**RE: SDCC REG. REF. SDZ22A/0005**

**PLANNING APPLICATION FOR THE PROVISION OF 436 NO. DWELLINGS (UP TO A MAXIMUM OF C. 37,402M GFA INCLUDING CAR PARKING) IN DEVELOPMENT AREA 11 – ADAMSTOWN STATION**

**RESPONSE TO REQUEST FOR FURTHER INFORMATION**

Figure 1: Extract from Technical Note, prepared by Atkins Consulting Engineers showing 3no. bus layby areas and turning area on Station Road.

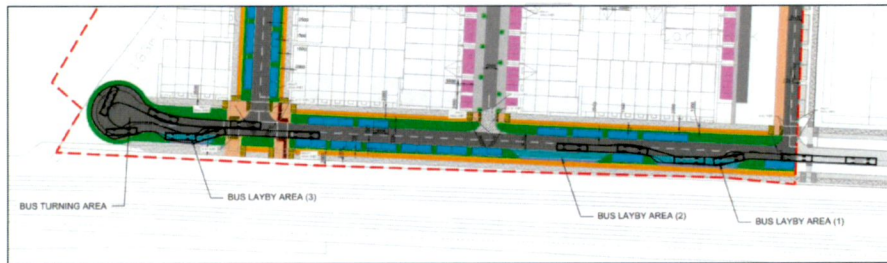
*(g) The applicant is requested to provide details of bus set down areas.*

(g) We refer the Planning Authority to page 9 of the enclosed Technical Note, prepared by Atkins Consulting Engineers which outlines the bus set down and turning areas on Station Road.
